CALIFORNIA COASTAL COMMISSION

May 21, 1998

RE: **Notice of Impending Development 2-97, Pursuant to the University of California Santa Barbara Certified Long Range Development Plan (LRDP) for Public Hearing and Commission Action at the meeting of June 9, 1998 in Santa Barbara.**

SUMMARY AND STAFF RECOMMENDATION

EXHIBIT 3a
UCSB NOID 2-97
Site Plan

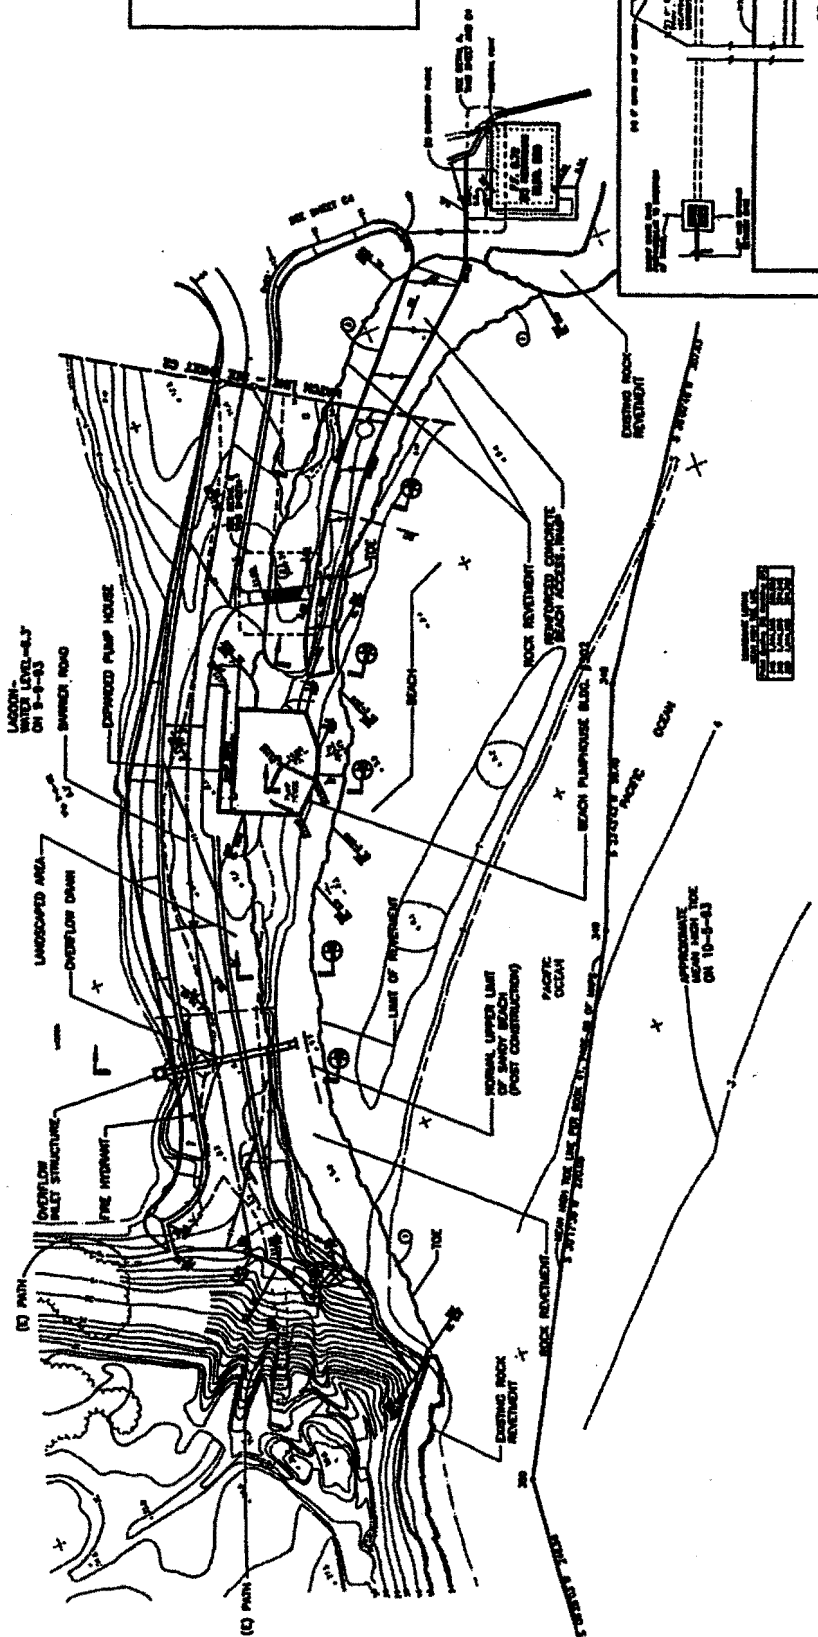
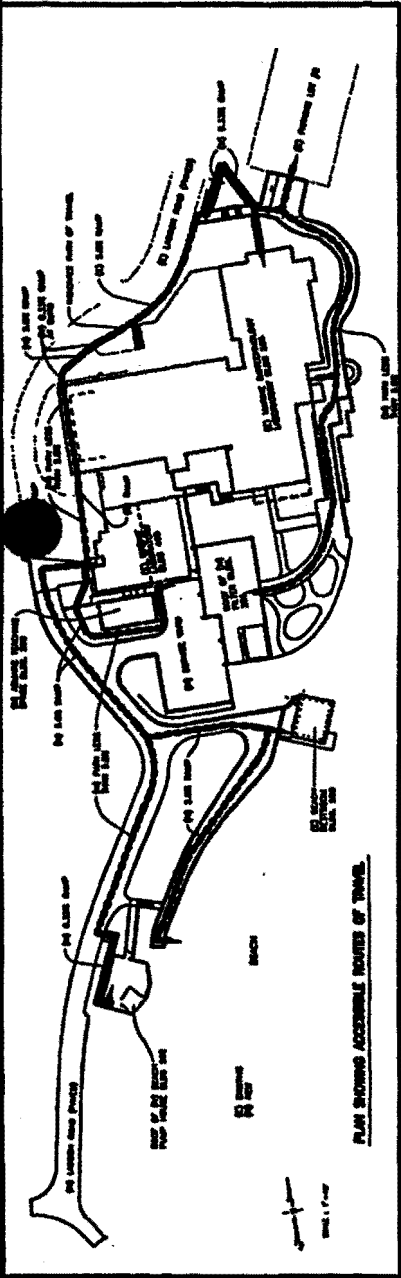
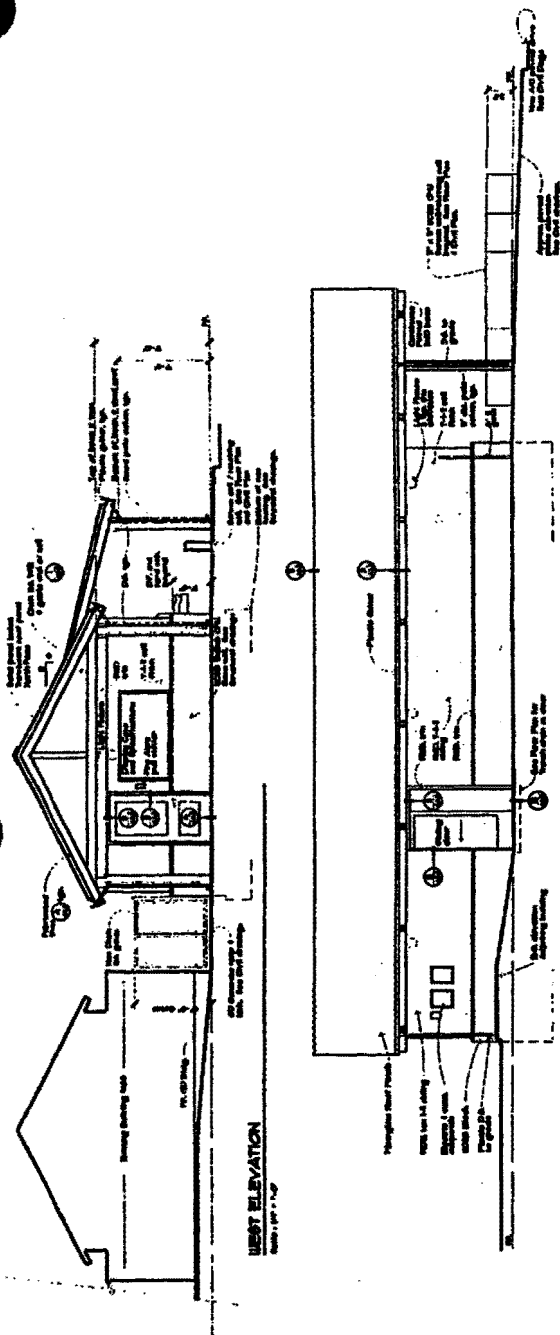
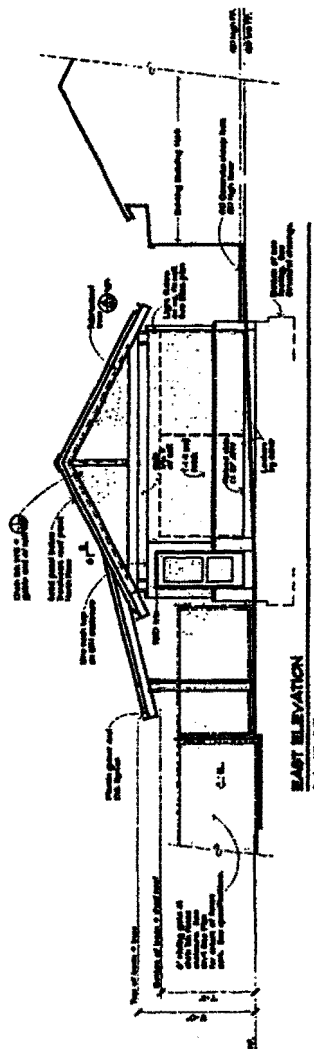
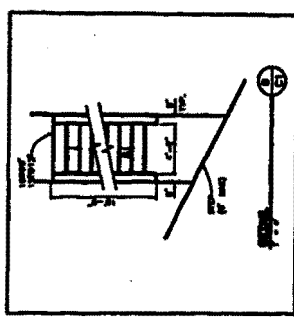
Although pavement of the access road in its present configuration and the construction of a turnaround will not adversely impact sensitive habitat, the proposed grading of the barrier will result in the filling of 0.01 acre of the lagoon wetlands and has been identified in the Environmental Impact Report submitted for this notice as a significant impact. In addition, the pavement of an access road atop the proposed 700 cu. yds. of fill would constitute the construction of a new, or reconfigured, road across the lagoon barrier. Although the amount of fill which will impact the Lagoon wetlands is minimal and the University has proposed 1:1 replacement mitigation in the Environmental Impact Report submitted for this notice, the

Commission notes that this activity is not consistent with LRDP policy 30233(a)1. As such, the placement of fill in order to increase the height of the lagoon barrier and construct a new road is not consistent with the applicable habitat protection policies of the LRDP. In addition, the Commission notes that the placement of fill along the barrier is integrally related to the construction of a rock revetment (proposed as part of the related LRDP Amendment 2-97 and Coastal Development Permit 4-97-156) which would also result in significant impacts to the beach ESHA. As such, the placement of fill to increase the height of the lagoon barrier is only necessary in conjunction with the proposed rock revetment. Further, the placement of fill in order to increase the height of the lagoon barrier is not consistent with Part 2, Chapter VI, Section D of the 1990 LRDP as recommended by modification one of LRDP Amendment 2-97 which would prohibit the placement of fill in order to increase the height of the existing lagoon barrier. Therefore, special condition two (2) has been required in order to ensure that the proposed improvements to the lagoon barrier do not include the placement of fill that would increase the height of the barrier.

Although pavement of an access road in its present configuration and the construction of a turnaround will not adversely impact public access, the placement of 700 cu. yds. of fill in order to raise the height of the revetment to 11 ft. MSL will create a difference in elevation between the access road and the sandy beach (sand elevation is approximately 5 ft. MSL at the lagoon barrier according to University information) of approximately 6 ft effectively restricting or eliminating public access to the sandy beach. In addition, the pavement of an access road atop the proposed 700 cu. yds. of fill would constitute the construction of a new, or reconfigured, road across the lagoon barrier. As such, the placement of fill in order to increase the height of the lagoon barrier and construct a new road is not consistent with the applicable public access policies of the LRDP. In addition, the Commission notes that the placement of fill along the barrier is integrally related to the construction of a rock revetment (proposed as part of the related LRDP Amendment 2-97) which would also result in significant impacts to public access to and along the beach which is located within public tidal lands. The placement of fill to increase the height of the lagoon barrier is only necessary in conjunction with the proposed rock revetment. Further, the placement of fill in order to increase the height of the lagoon barrier is not consistent with Part 2, Chapter VI, Section D of the 1990 LRDP as recommended to be modified by modification one of LRDP Amendment 2-97 which would prohibit the placement of fill in order to increase the height of the existing lagoon barrier. Special condition two (2) has been required in order to ensure that the proposed grading does not interfere with public access to the sea.

Prior to the commencement of development, the University shall submit, for the review and approval of the Executive Director, revised plans prepared by a qualified civil engineer which eliminates the placement of fill which would increase the height of the existing lagoon barrier above its present elevation.
